SUPPLEMENT

PAJERO '95

ELECTRICAL WIRING SUPPLEMENT

This publication is a supplement to the Electrical Wiring Manual Pub. No. PHJE9026 and contains only additions and changes to the original issue. It is recommended that all service mechanics engaged in the servicing of the vehicle refer to the following publications as well as this manual.

6G74 engine-M/T

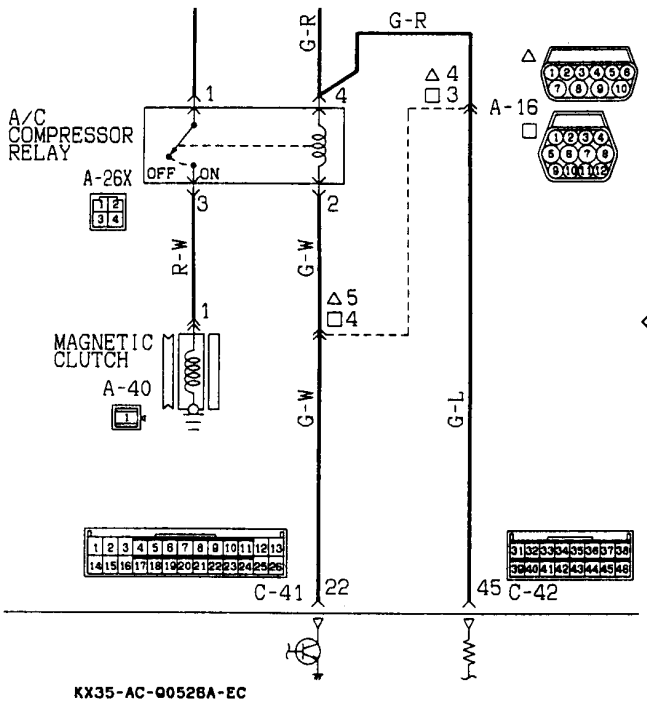
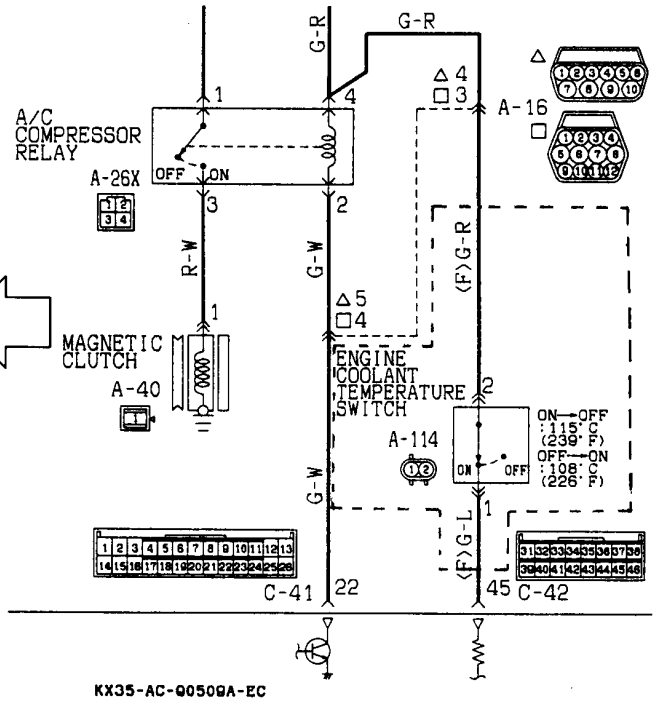
- The engine coolant temperature switch has been abolished.

6G74 engine-A/T

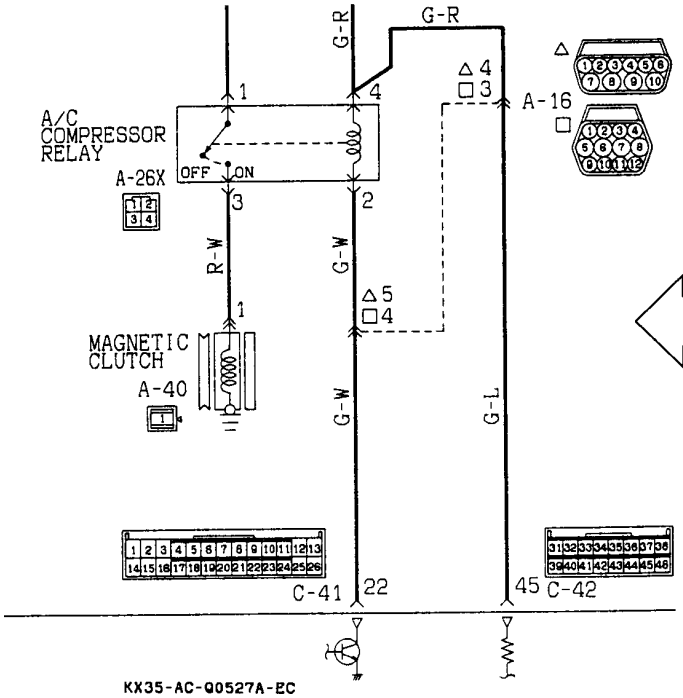
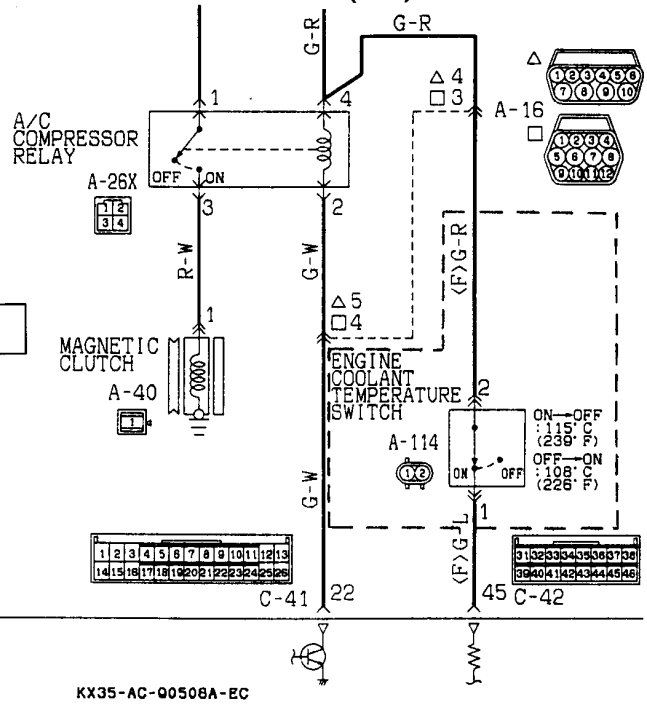
- The engine coolant temperature switch has been abolished.

6G72, 6G74 engine

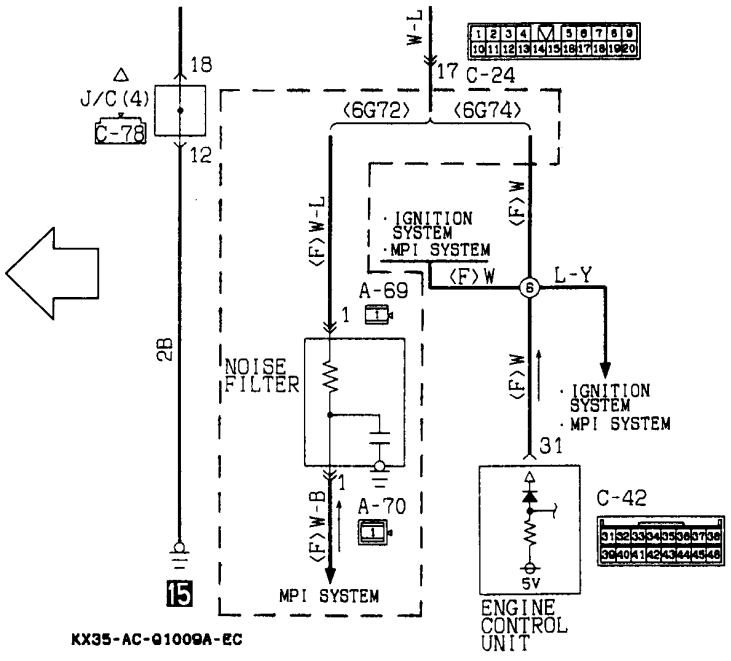
Revising the engine control unit has changed this circuit. <Vehicles with 6G72 engine>

L.H. drive vehicles <4G64, 6G72 engine>

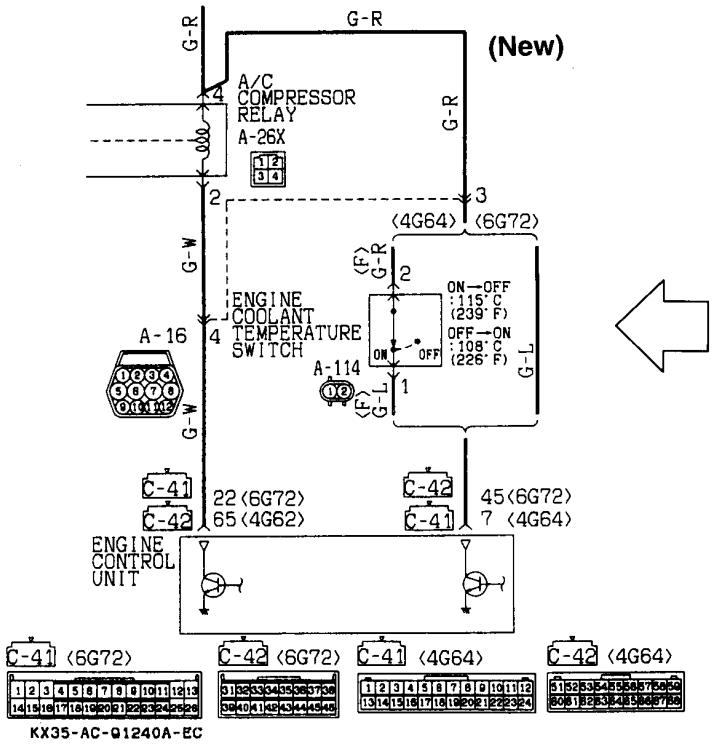
- The engine control unit has been changed. <Vehicels with 6G72 engine>
- The engine coolant temperature switch has been abolished. <Vehicles with 6G72 engine>

R.H. drive vehicles <Petrol-powered vehicles>

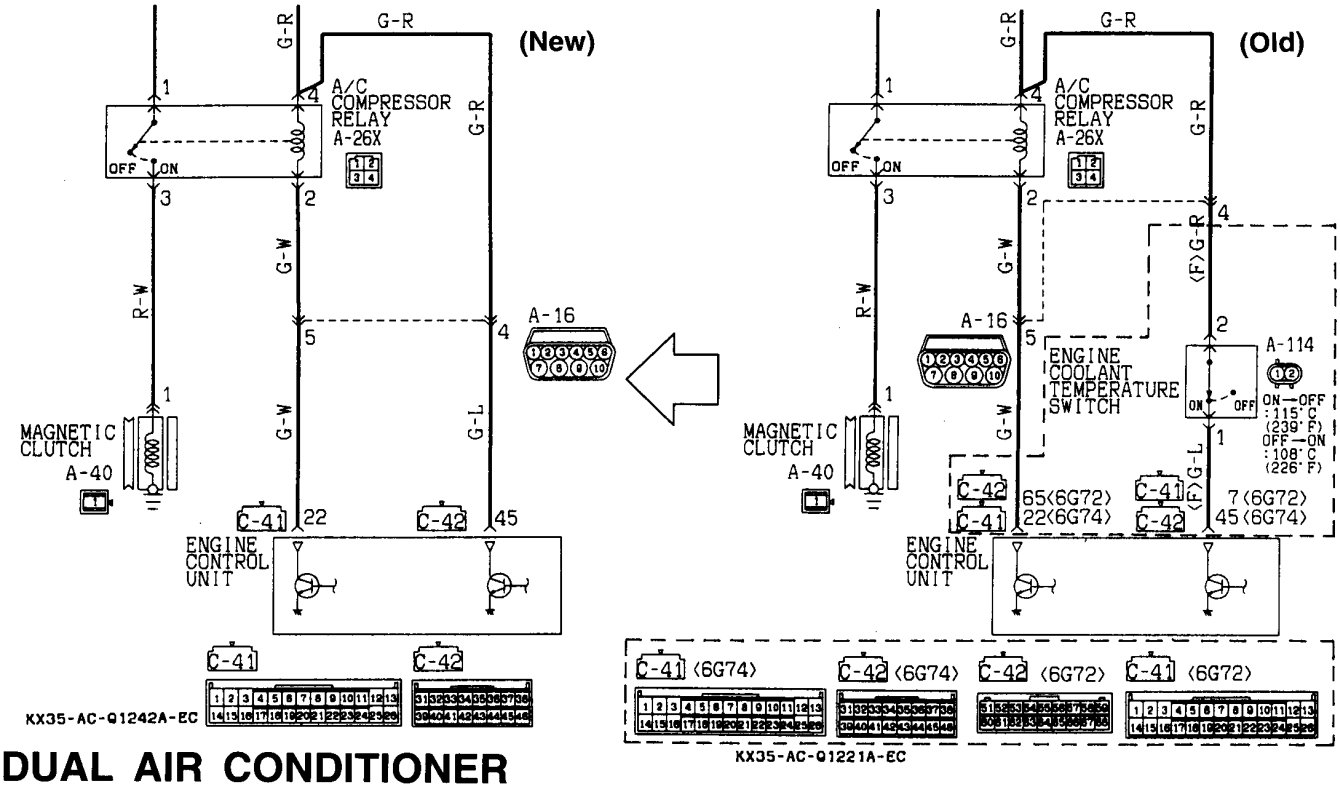
- The engine control unit has been changed. <Vehicles with 6G72 engine>
- The engine coolant temperature switch has been abolished.

L.H. drive vehicles without rear heater <Petrol-powered vehicles>

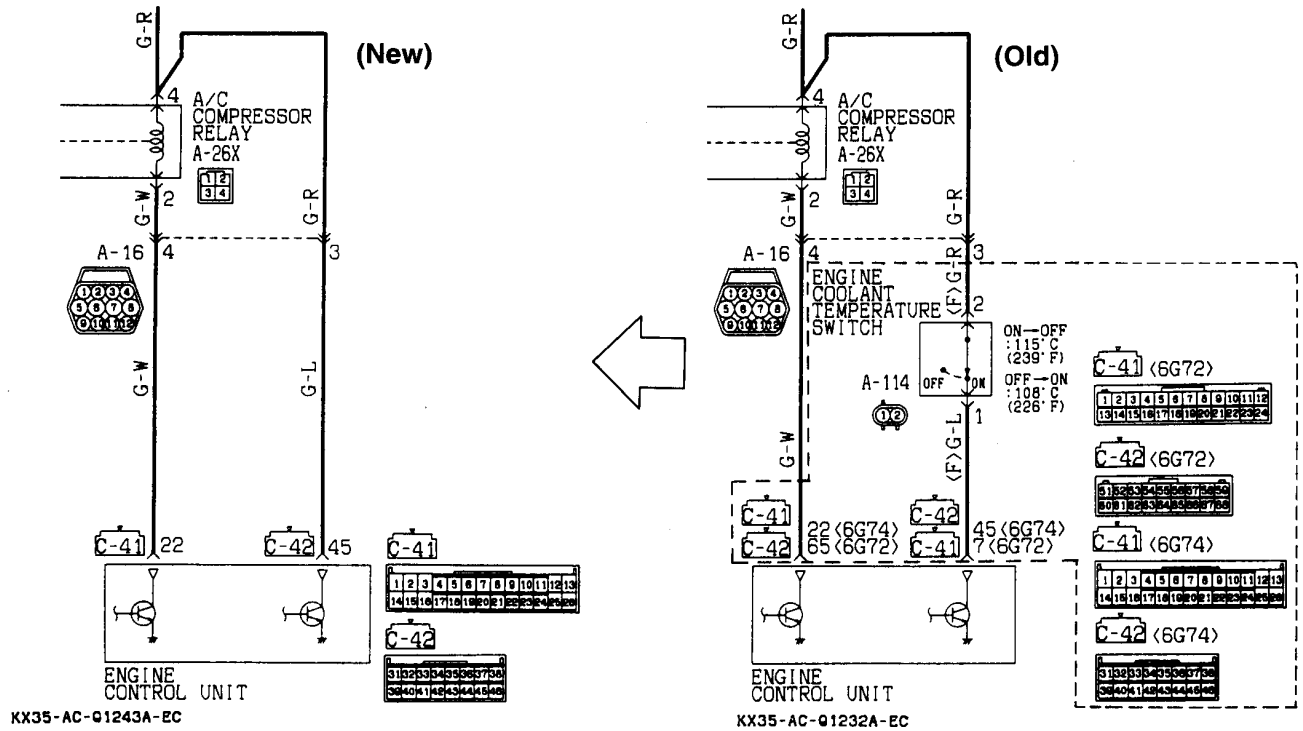
- The engine control unit has been changed. <Vehicles with 6G72 engine>
- The engine coolant temperature switch has been abolished.

L.H. drive vehicles with rear heater <Petrol-powered vehicles>

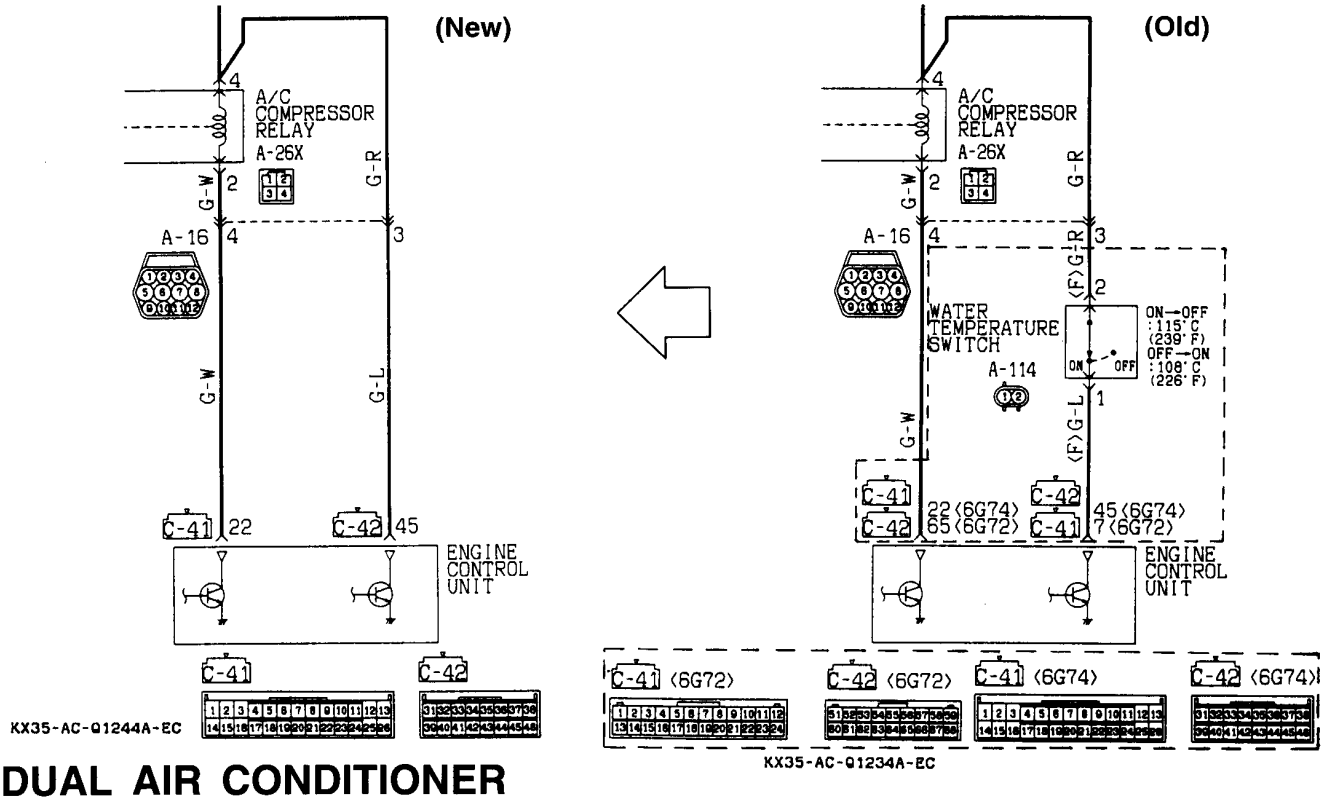
- The engine control unit has been changed. <Vehicles with 6G72 engine>
- The engine coolant temperature switch has been abolished.

R.H. drive vehicles without rear heater <Petrol-powered vehicles>

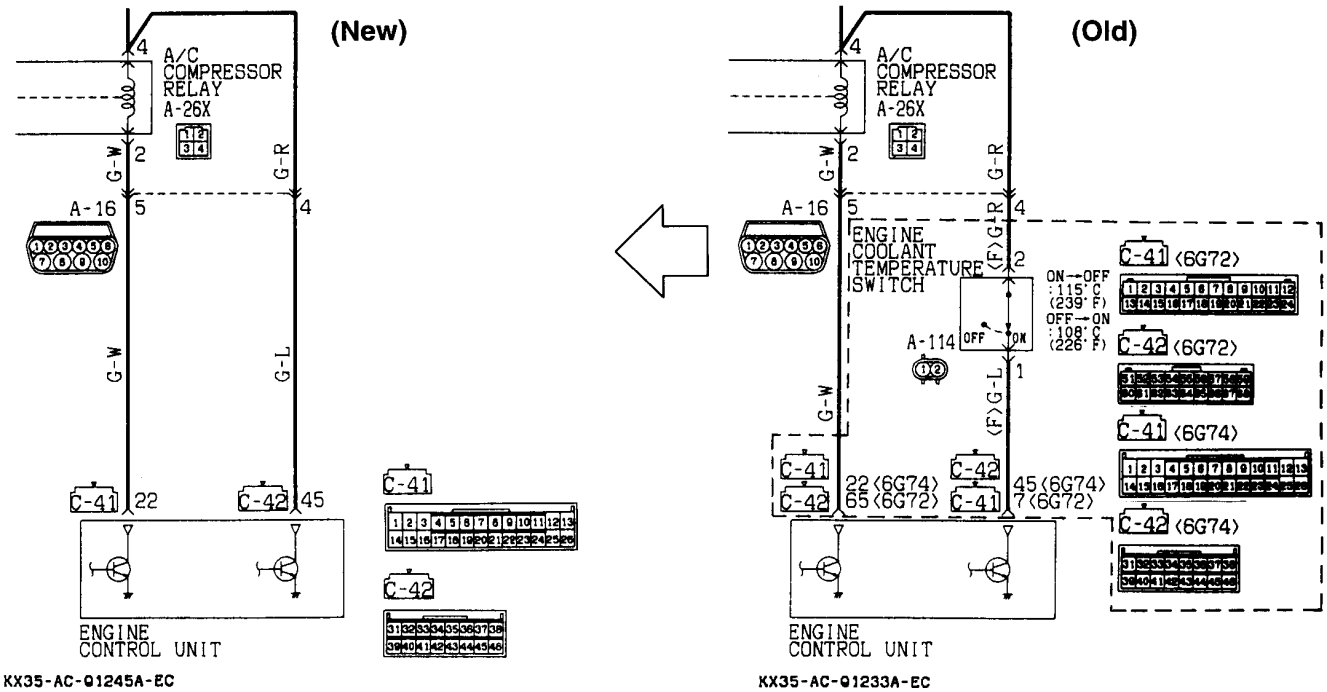
- The engine control unit has been changed. <Vehicles with 6G72 engine>
- The engine coolant temperature switch has been abolished. <Vehicles with 6G72 engine>

R.H. drive vehicles with rear heater <Petrol-powered vehicles>

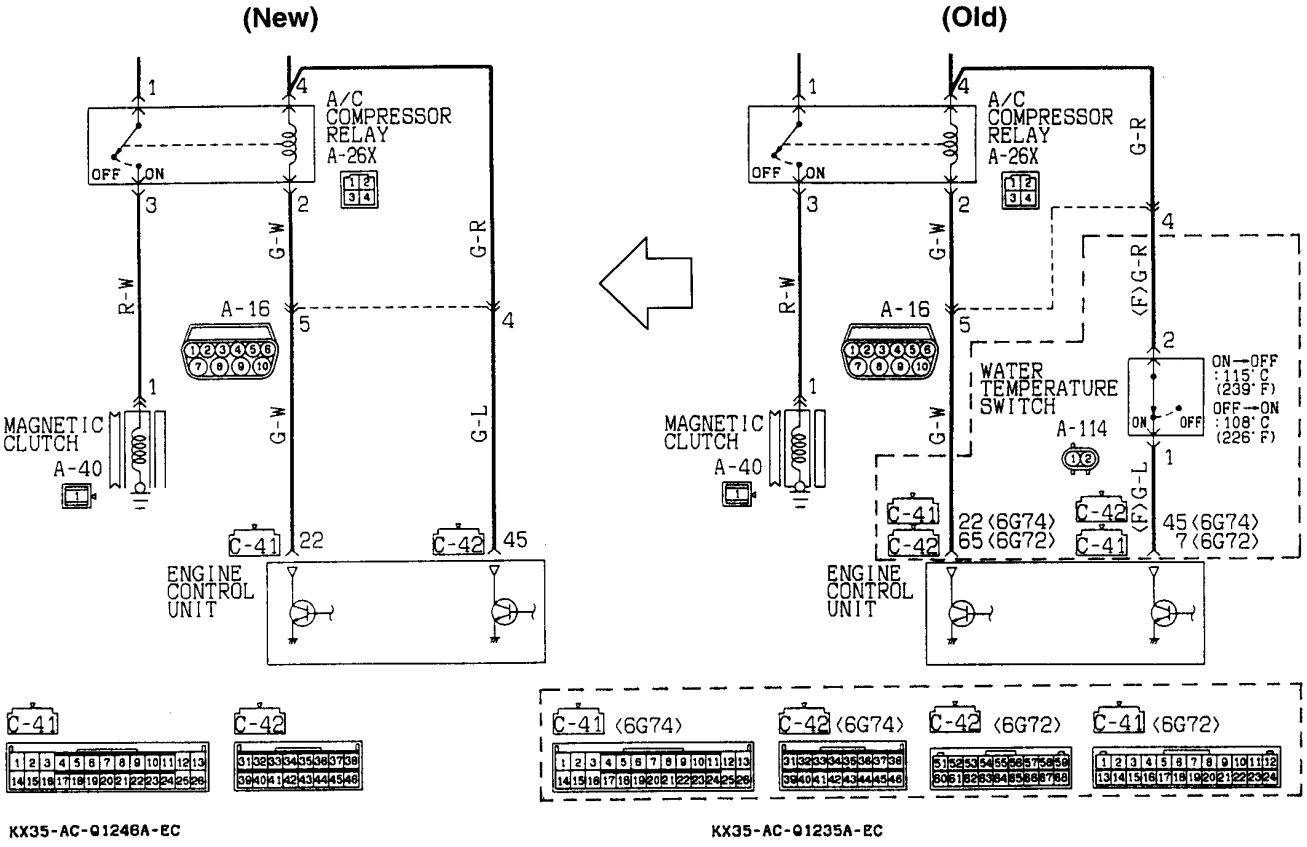
- The engine control unit has been changed. <Vehicles with 6G72 engine>
- The engine coolant temperature switch has been abolished.

L.H. drive vehicles <Petrol-powered vehicles>

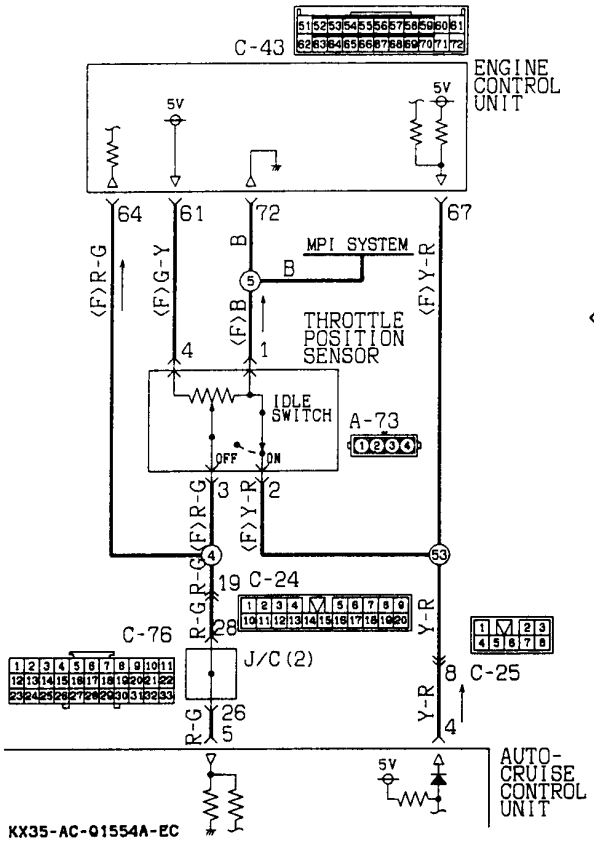
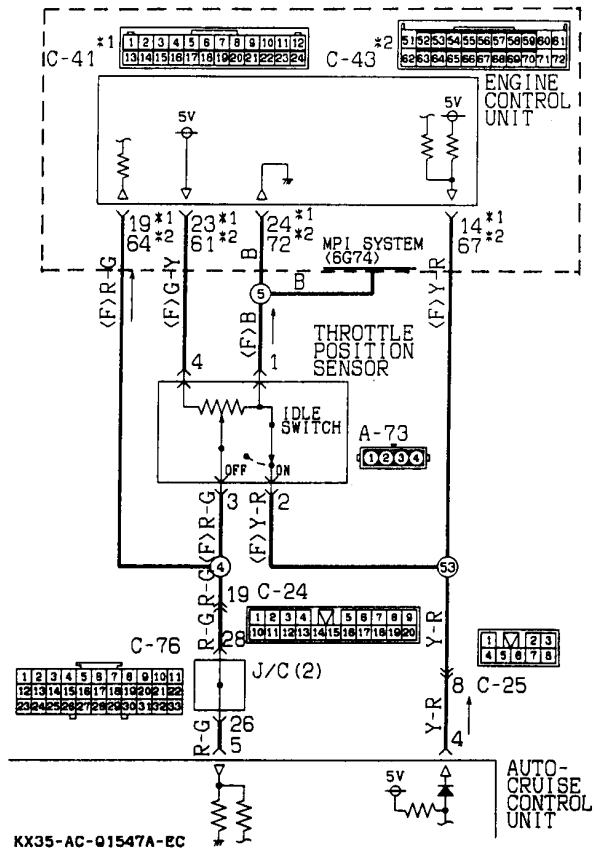
- The engine control unit has been changed. <Vehicles with 6G72 engine>

R.H. drive vehicles <Petrol-powered vehicles>

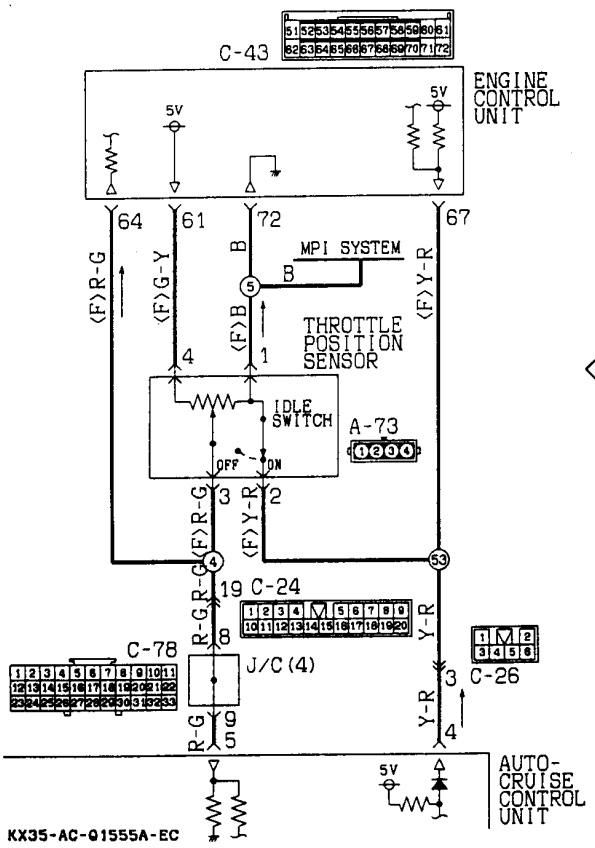
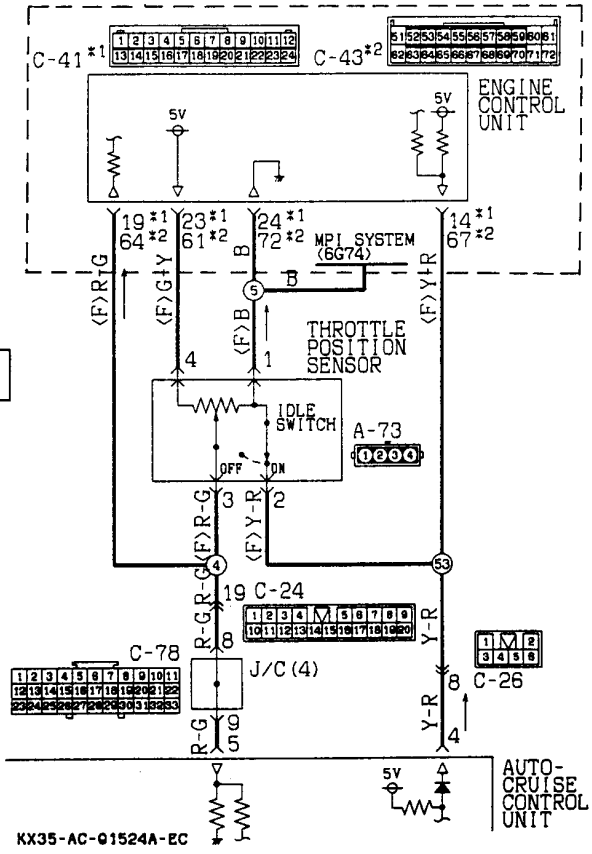
- The engine control unit has been changed. <Vehicles with 6G72 engine>

Petrol-powered vehicles

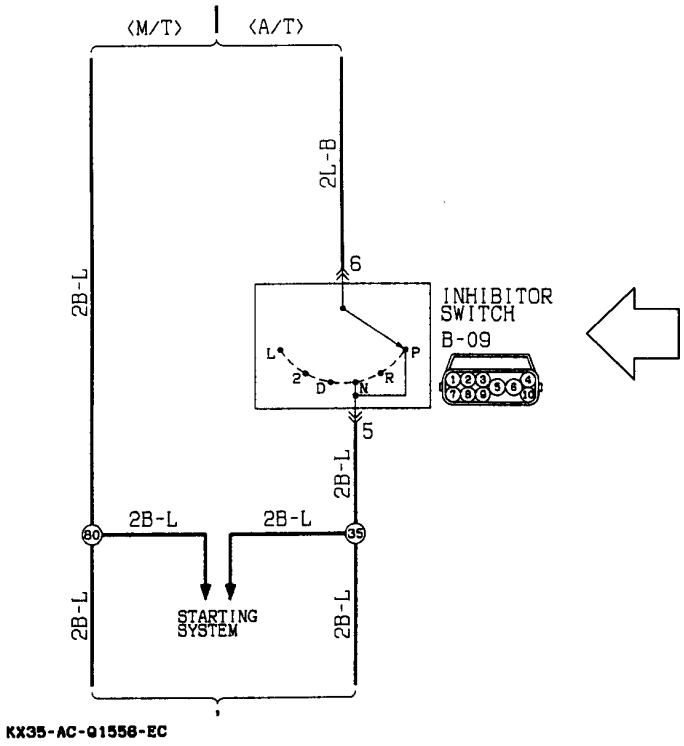
The inhibitor switch has been changed. <Vehicles with 6G72 engine>
